2004 Ford Mustang V8-4.6L SOHC VIN X

M/T - MERCON(R) V ATF USAGE INFORMATION

TSB 06-26-1

MERCON ATF IS BEING REPLACED BY MERCON V
AS A SERVICE FLUID FOR SOME MANUAL
TRANSMISSIONS

Figure 1

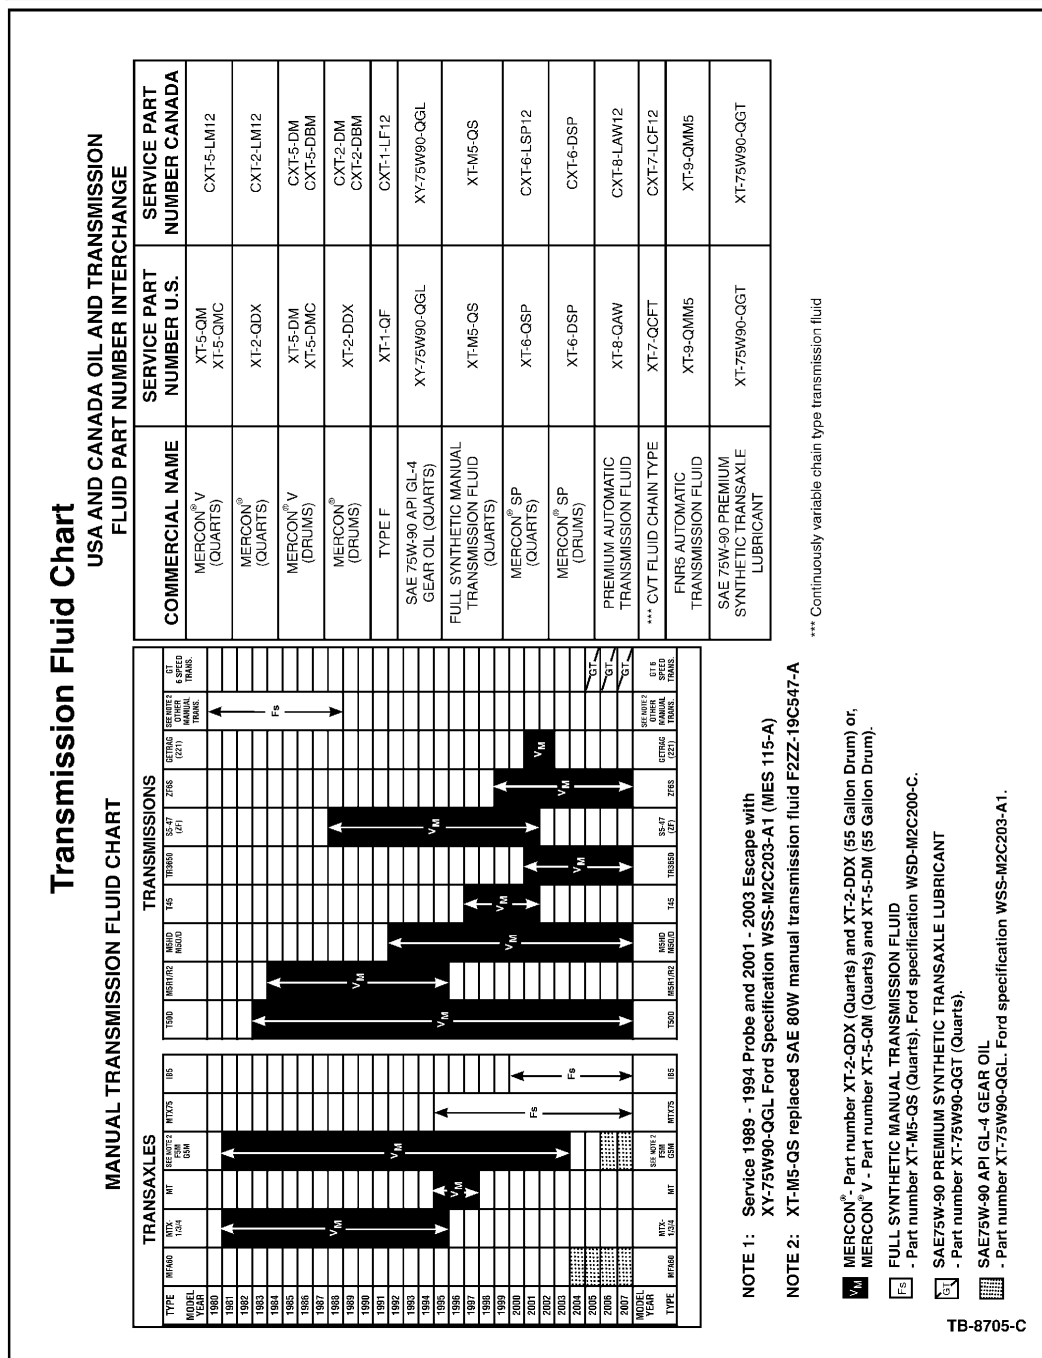
Service manual transmissions requiring MERCON(R) with MERCON(R) V or MERCON(R) Automatic Transmission Fluid or dual usage fluids labeled MERCON/MERCON(R) V. For proper fluid application on current and past model manual transmissions refer to the fluid usage chart. (Figure 1)
